Subject: Proponent response to IR CEAA 105: update to Howse water management plan

REQUEST FOR REVIEW:
HOWSE PROPERTY PROJECT

**Water Management Plan
Comparison**
Howse Minerals Limited

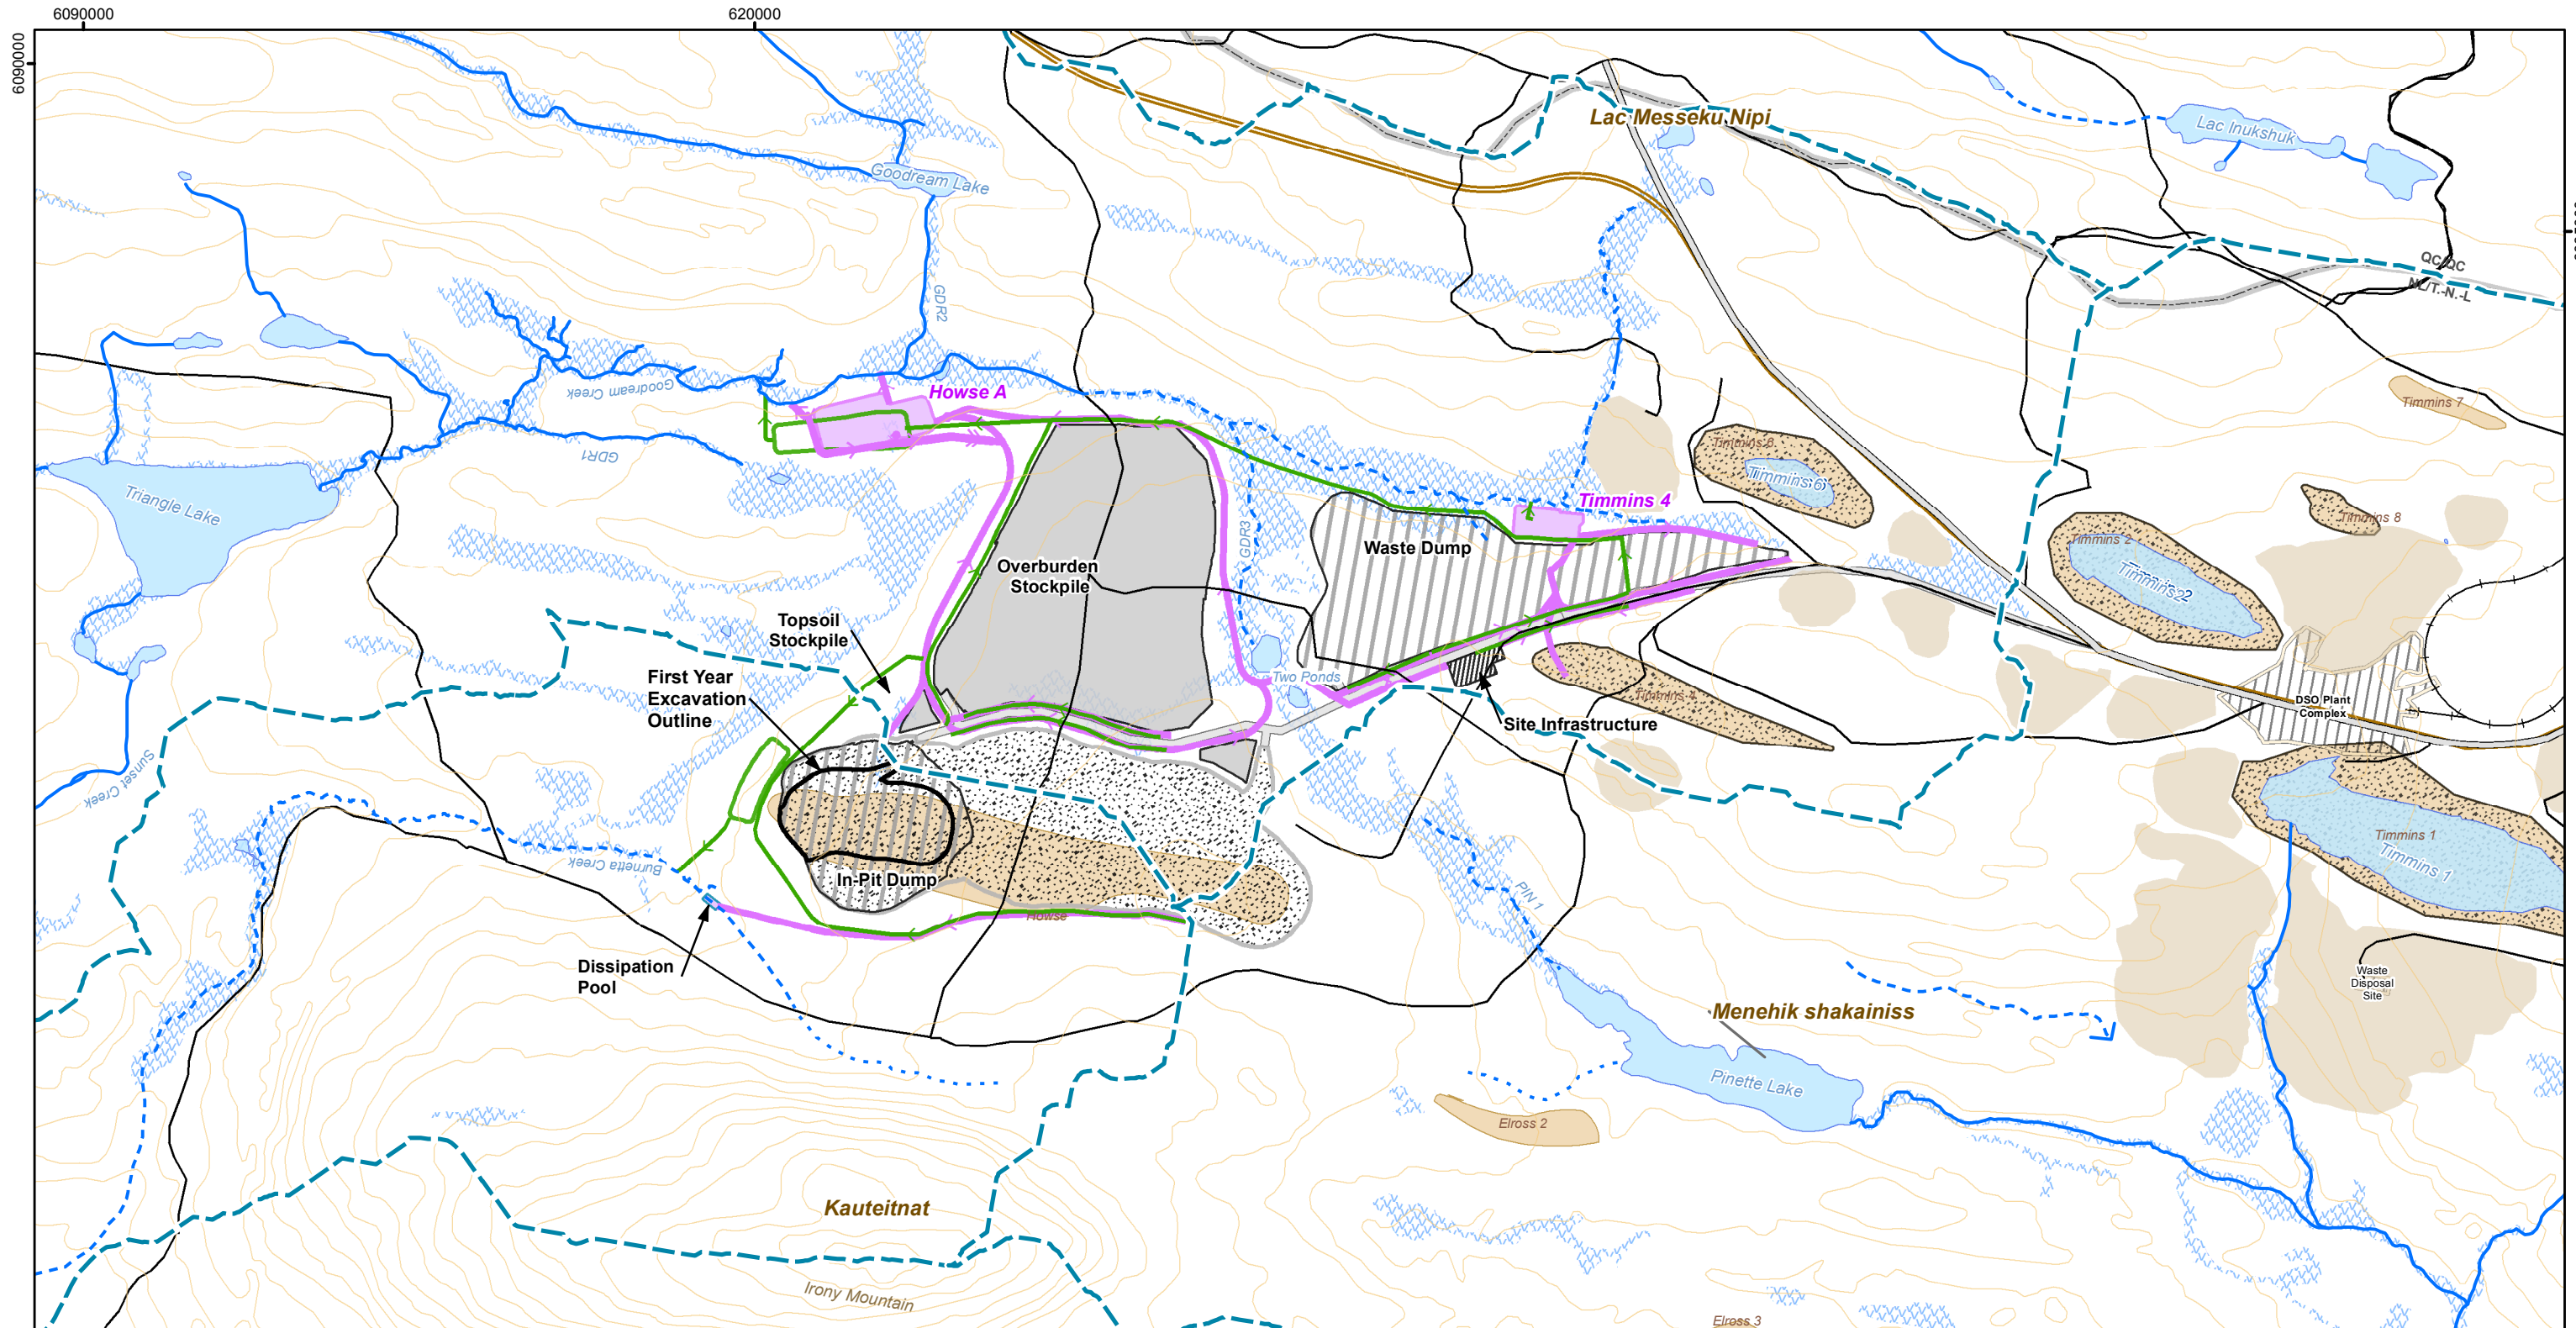
The Howse Property lies on three different watersheds leading to Pinette Lake, Burnetta Creek and Goodream Creek. The water management strategy aims to manage surface runoff and pit dewatering water with as little effects as possible on them. The WMP will avoid construction in sensitive areas like wetlands and will minimize flow variations in existing natural creeks. Further, existing infrastructure will be used, such as the Timmins 4 settling pond 3. Water treatment will consist of removing suspended sediments by means of two (one new) settling ponds.

The water management strategy is as follows:

- Instead of being treated with mine water, the natural runoff from Irony mountain will be collected by a ditch located north-west from the pit, before reaching the mine site, and leading to a dissipation pool ultimately discharging into Burnetta Creek;

- the west part of the in-pit waste rock dump, the topsoil stockpile and from the surrounding area on the south-west side of the site (formerly directed towards Burnetta Creek) will be collected by a ditch leading to Settling pond HOWSEA and then discharged to Goodream Creek;

- runoff on the waste rock dump, the site infrastructure pad, and the overburden stockpile will be collected by ditches leading to Settling pond HOWSEA and then discharged into Goodream Creek (unchanged from previous WMP); and

- since underground water will seep into the Howse pit as the pit depth reaches the water table, pit dewatering will consist of pumping the water that accumulates into the pit and diverting it to a ditch on the north-east side of the pit, leading to settling pond HOWSEA, and then discharged into Goodream Creek. The portion of the ditch receiving the dewatering water along the pit will be waterproofed to avoid infiltration of water directly back into the pit (unchanged from previous WMP).
